Title of Change:	AR0431 Datasheet
Effective date:	21 May 2020
Contact information:	Contact your local ON Semiconductor Sales Office or Sonya.Yip@onsemi.com
Type of notification:	This Product Bulletin is for notification purposes only. ON Semiconductor will proceed with implementation of this change upon publication of this Product Bulletin.
Change Category:	Documentation Change
Change Sub-Category(s):	Datasheet/Product Doc change

The AR0431 datasheet has been updated with changes to trigger mode information. These changes do not affect form, fit, or function of the product.

Figure 20. Trigger Mode Block Diagram

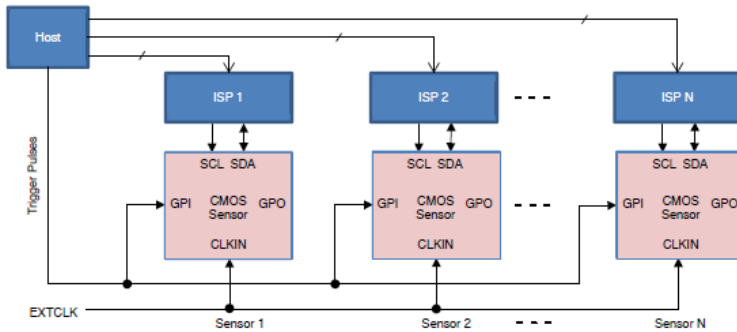
6. Removed “Figure 20, Trigger Mode Block Diagram”
